Auckland Council
Private Bag 92300
Auckland 1142

Keith Hay CC9 - BUN60382589, Response to further queries

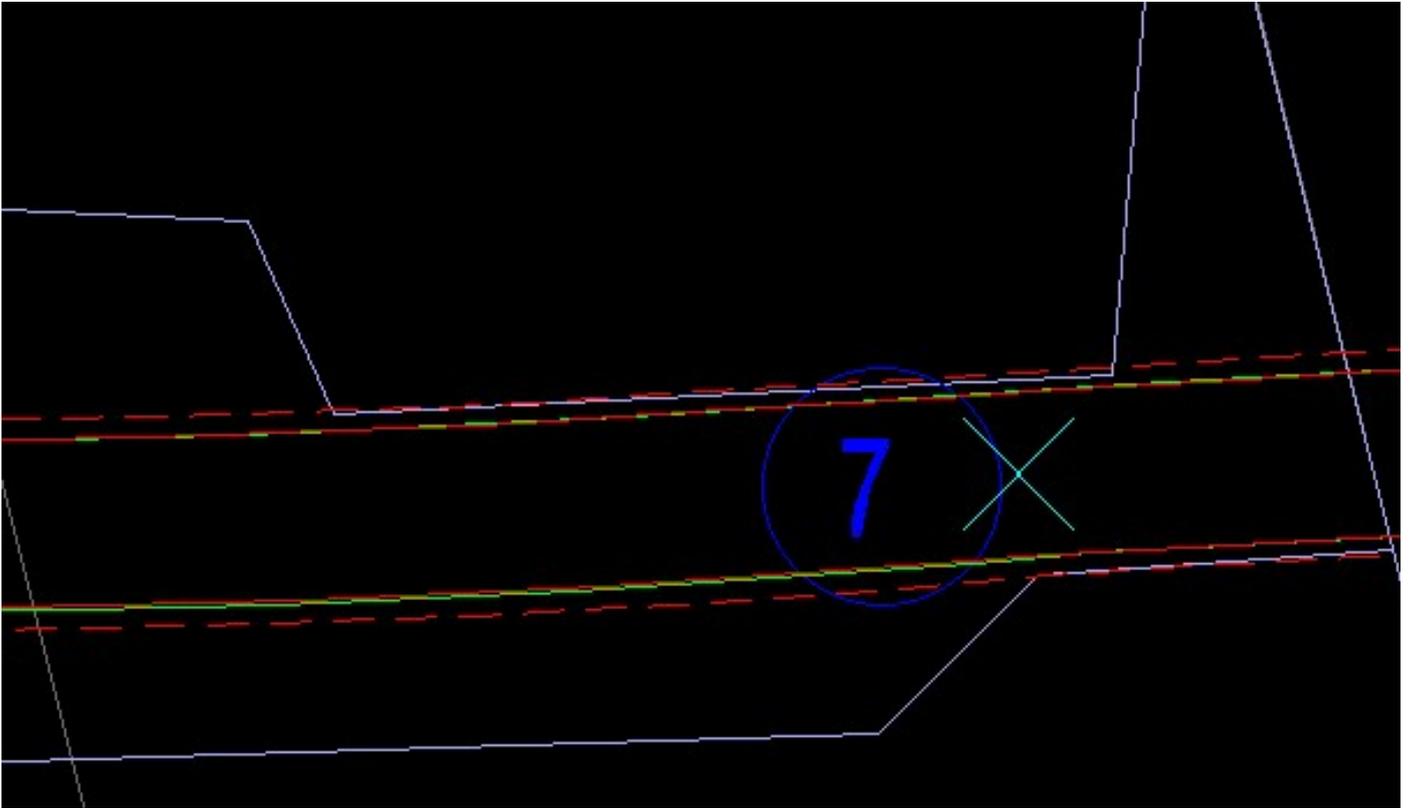
- I am a bit concerned about the tracking assessment for an 8.3 metre truck accessing the Eden Roskill Cricket Club via Norton Road. There is a single file restriction at the entrance to this car park, which according to the applicant, measures 3.0 metres in width, which is tight for a 2.5 metre-wide truck.*

If we look more closely at the tracking plot, we can see that the tracking in fact illustrates the truck overlapping the side of the bridge structure on one side, and coming close to an electric pylon on the other.

Accordingly, this tracking needs to be redone to show the truck profile clear of both constraints (if it is indeed correct that this is a 3-metre gap versus a 2.5-metre wide truck). I would also request from the applicant the provision of appropriate mitigatory measures, e.g. an on-road 'observer' to help alert the truck driver of the above hazards.

- *Below is the screenshot of the vehicle tracking without the aerial. We've done this as sometimes the aerials can be misleading as they are not taken from directly above and therefore slightly skew or distort the image and associated ground features. We've provided the image with the aerial further below. Please note:*

- *the crosses are the points in the vehicle tracking software where the computer mouse was pressed i.e. where the programme is told to change the direction of the vehicle.*

- *The 7 is not relevant to the assessment but simply indicates that this is the 7th tracking manoeuvre completed.*
- *The purple lines in the image are the **impervious surface extents**. These are taken from Auckland Council GeoMaps which are more accurate than those shown in the aerial (due to the issue identified above).*

- *The tracking of the 8.3m truck is shown by the red (outline of truck) and green-yellow lines (the green-yellow line is the 'swing' as the truck goes around a curve).*

- *As shown, **the 8.3m truck sits within the extent of the impervious surface/road** (shown in purple). However the clearance area (additional 300mm either side of the truck shown by the outer red dashed lines) overlaps slightly. Note however that the vehicle tracking is already conservative as the red tracking lines include the truck to the outer extent of its mirrors, and the clearance then area adds an additional factor of safety on to this when completing vehicle tracking. **We therefore consider the truck can access the site clear of constraints.***

- *Further to this, the pylon is set back from the curb and tapers inwards so we do not consider there will be any issues with a truck navigating past it. However the assessor raises a good point and **providing a spotter is a good idea – this would be covered in the CTMP.***
